DeKalb County Jail Expansion

November 1, 2016 Project Status Update

Condensing Units in Area Well

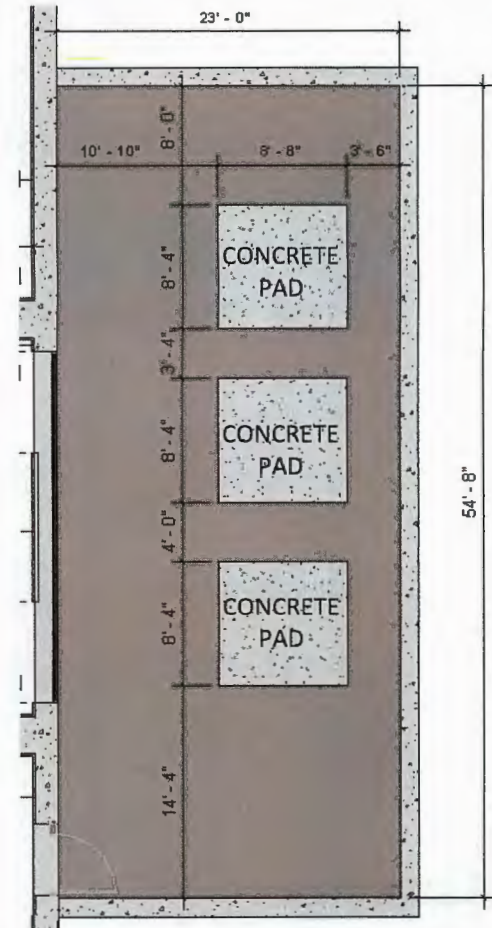
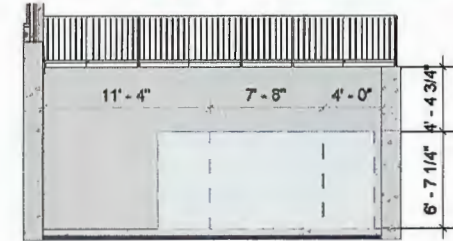
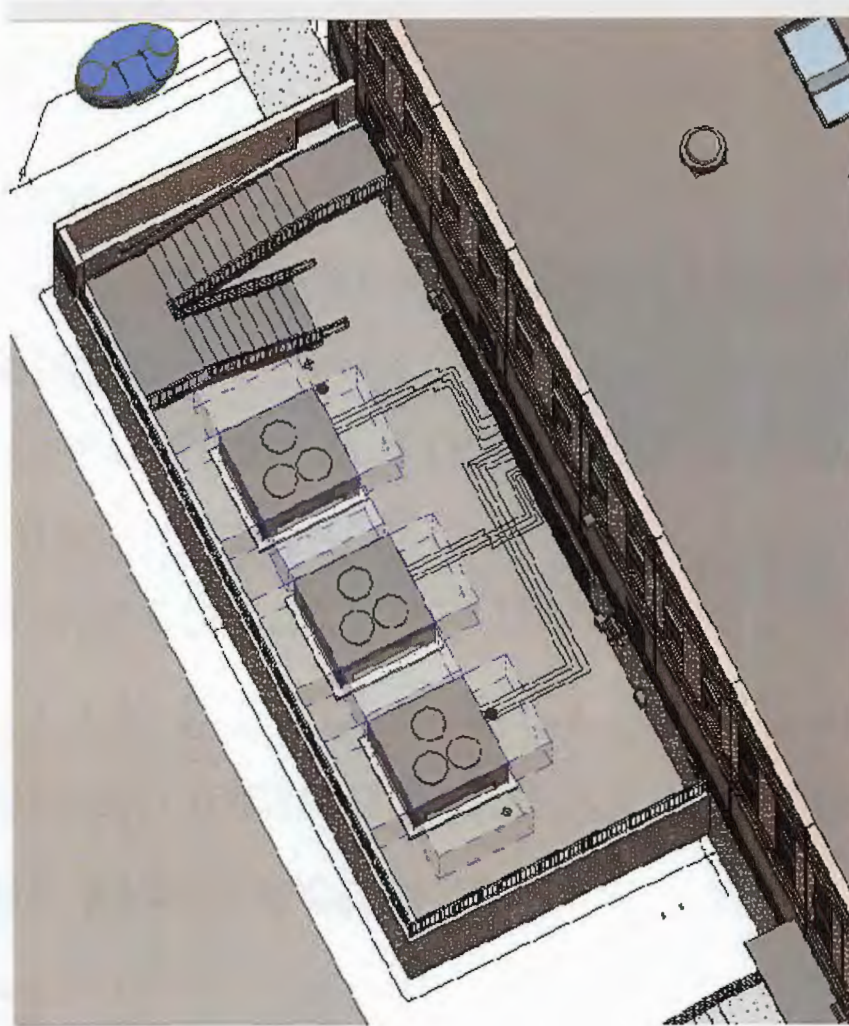
With that much additional space I believe you will be OK, but I don't have a way to model it to provide a guarantee that there would be no issues. With the wall being 11 feet all the way around, there is always a chance that recirculation could occur.

It appears there is adequate space for air circulation and all the manufacturer's clearances have been met. We could potentially install a baffle plate between the units to direct hot exhaust air up to reduce recirculation if there is an issue. We have asked the manufacturer's representative for a potential fix we can share with the client in case we find out next summer air recirculation is occurring. We're waiting for their reply.
